Assessment of the Potential for Criticality in Decommissioned Spent Fuel Pools

Comments on NRC Draft Screening Criteria for Assessing Potential Seismic Vulnerabilities of Spent Fuel Pools at Decommissioning Plants - December 3, 1999 NRC Memorandum

Subject: Additional Documents Concerning Seismic Screening and Seismic Risk of Spent Fuel Pools For Decommissioning Plants

Figure 3.1 Assumed Spent Fuel Pool Cooling System

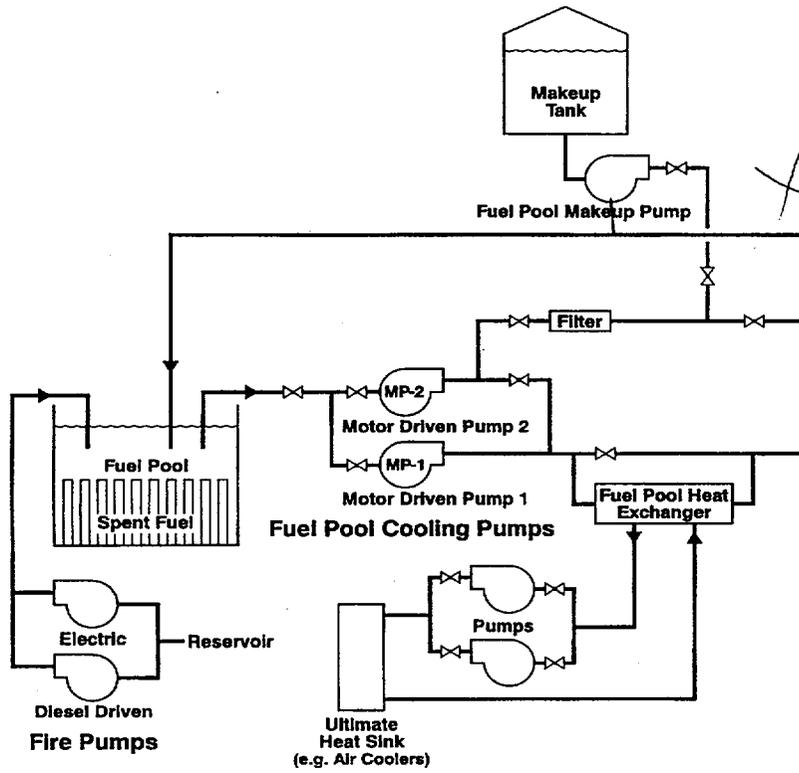
Based upon information gathered from the site visits and interactions with NEI and other stakeholders, the staff has modeled the spent fuel pool cooling system (SFPC) (see Figure 3.1 on next page) as being located in the spent fuel pool (SFP) area and consisting of motor-driven pumps, a heat exchanger, an ultimate heat sink, a makeup tank, filtration system and isolation valves.
